Date 5.2015    Group **215**    No. **002**    Release **02**    Page 1(2)

Timing Plate Leak Repair  
 D16  
 VN, VT

**FSB 215-002, Timing Plate Leak Repair**

W2098874

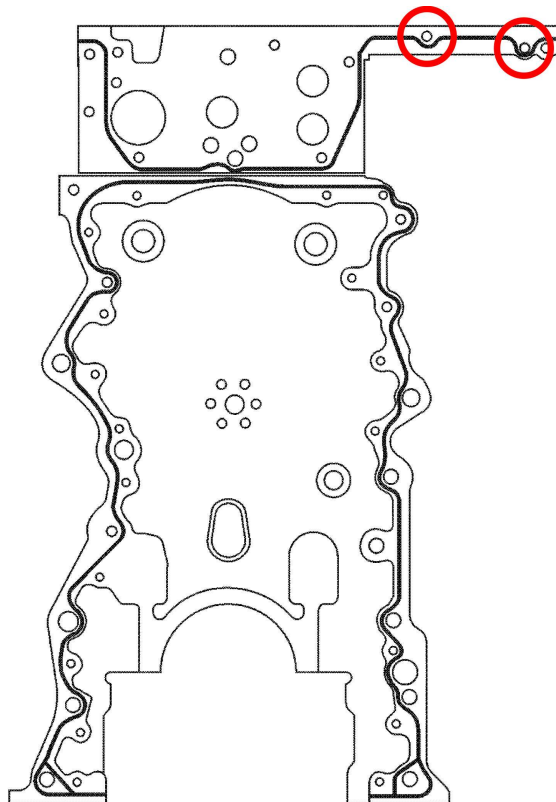
Oil leaks have been observed coming from the area that is at the rear of the engine, just under the lip of the valve cover, on the right side (exhaust side). It is typically seen as seeping, weeping, leaking oil and could be believed to be from the cylinder head gasket. Deeper investigation has found that the bolts (highlighted in the images below) that fasten the timing plate to the cylinder head are coming loose, which breaks the silicone seal and will allow oil to start leaking. This issue is only applicable to D16 engine serial numbers prior to 80059.

W2005981

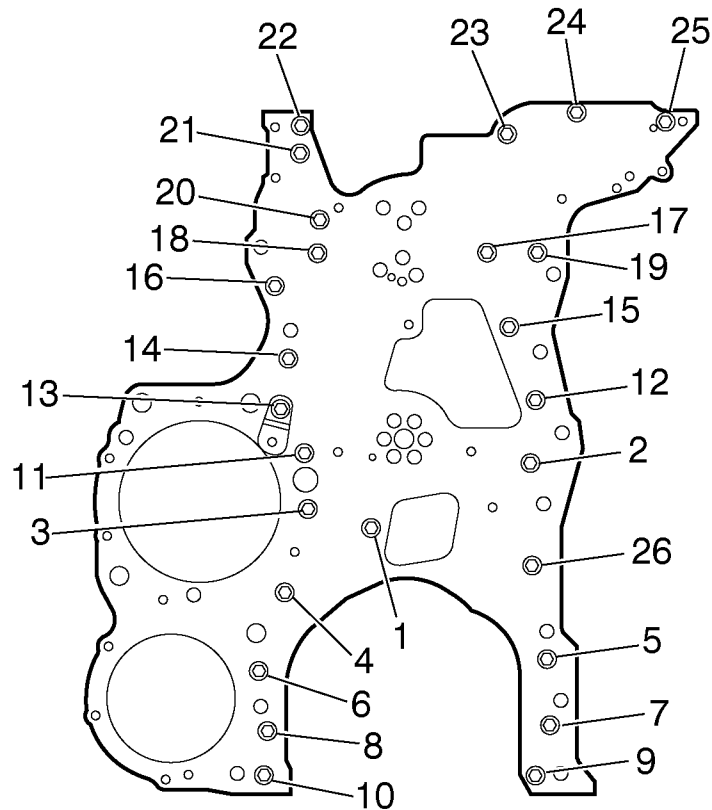
**Note:** Numbers in image indicate tightening sequence.

The repair for this requires gaining access to the rear of the engine block. Refer to the appropriate service information in Impact. It may be necessary to replace the timing plate if the plate is fretted severely. Thoroughly clean the block, fasteners and fastener holes. Replace all 25 M8\*25 timing plate screws with part number 994447 which have pre-applied locking compound (patch-lock).
